**STAFF RECOMMENDATION
250 Harding Place (0 Harding Place)
November 20, 2019**

Application: New Construction—Infill and Outbuilding
District: Belle Meade Links Triangle Neighborhood Conservation Zoning Overlay
Council District: 23
Base Zoning: R10
Map and Parcel Number: 13001014100
Applicant: Chris Goldbeck, P. Shea Design
Project Lead: Paul Hoffman; paul.hoffman@nashville.gov

<p>Description of Project: This application is for construction of a new residence and detached outbuilding.</p> <p>Recommendation Summary: Staff recommends approval with the conditions:</p> <ol style="list-style-type: none"> 1. The finished floor height shall be consistent with the finished floor heights of the adjacent historic houses, to be verified by MHZC staff in the field; 2. Staff approve a brick sample, color of roofing, windows, doors and garage doors, walkways and driveway; and, 3. HVAC and utilities shall be located behind the house or on either side, beyond the mid-point of the house. <p>With these conditions, Staff finds that the proposed infill and outbuilding meet Section II.B for New Construction of the Belle Meade Links Triangle Neighborhood Conservation Zoning Overlay.</p>	<p>Attachments

FRONT GARAGE ELEVATION
 SCALE: 1/4" = 1'-0"

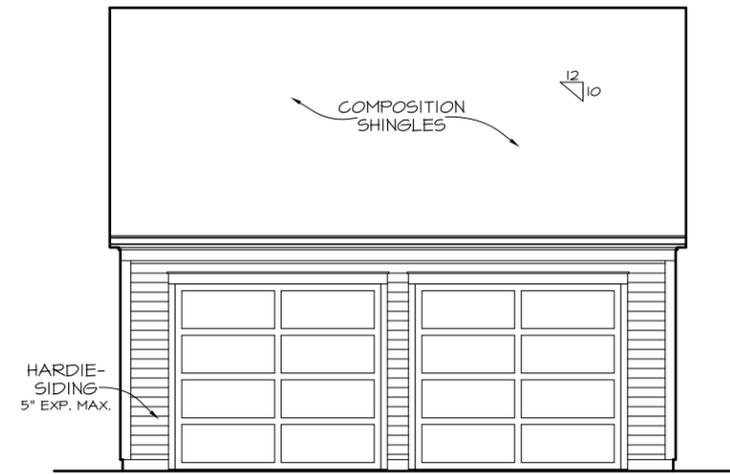
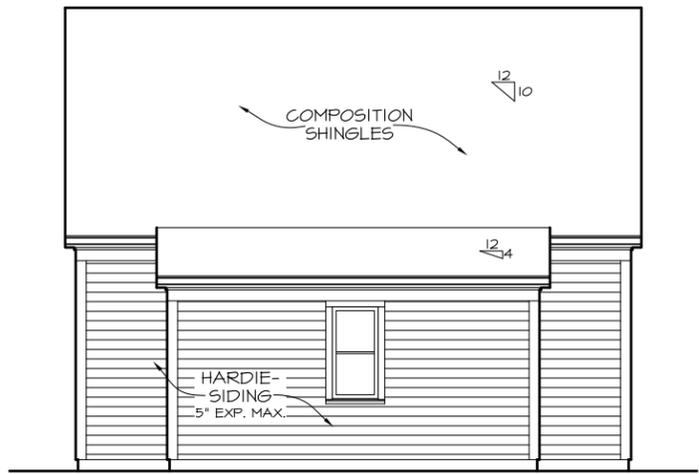
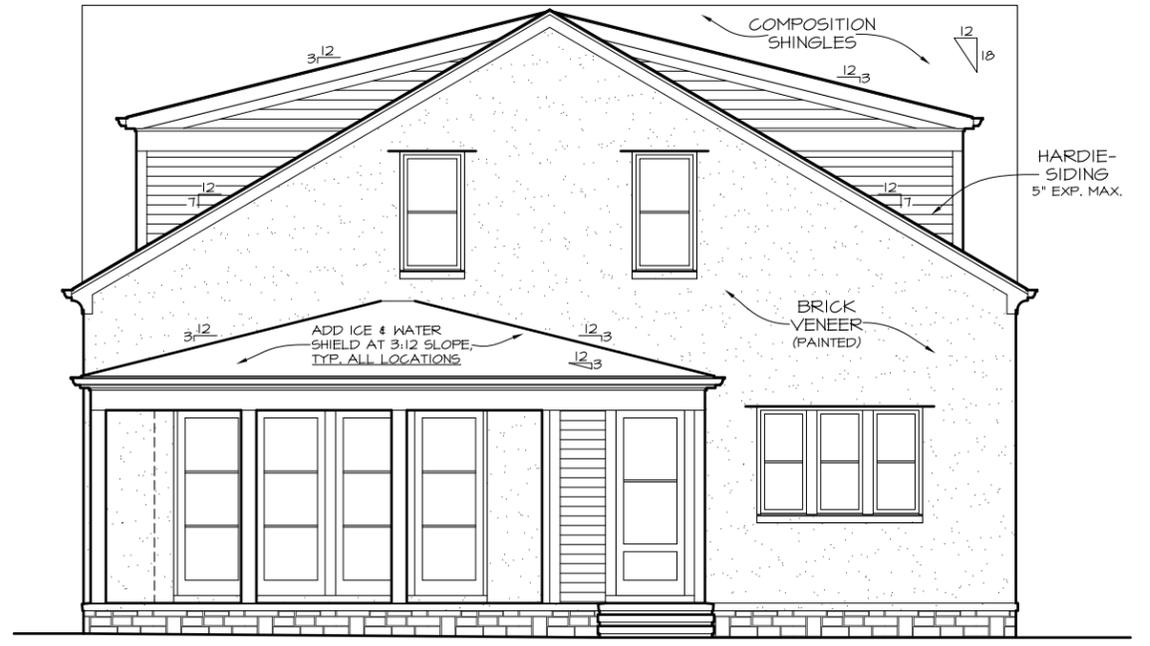
The lot is greater than 10,000 square feet, at twelve thousand, three-hundred and sixty-eight square feet (12,368 sq. ft.). The outbuilding footprint is six hundred and fifteen (615 sq. ft.), less than the one thousand (1,000) square feet which could be allowed.

The proposed ridge height will be approximately twenty feet (20') tall, which is less than the twenty-seven feet, six inches (27' 6") height of the house and less than the twenty-five foot (25') maximum. The eave height will be about nine feet (9'), which is subordinate to the house.

Staff finds that the proposal will meets Section II.B.1.h of the design guidelines.
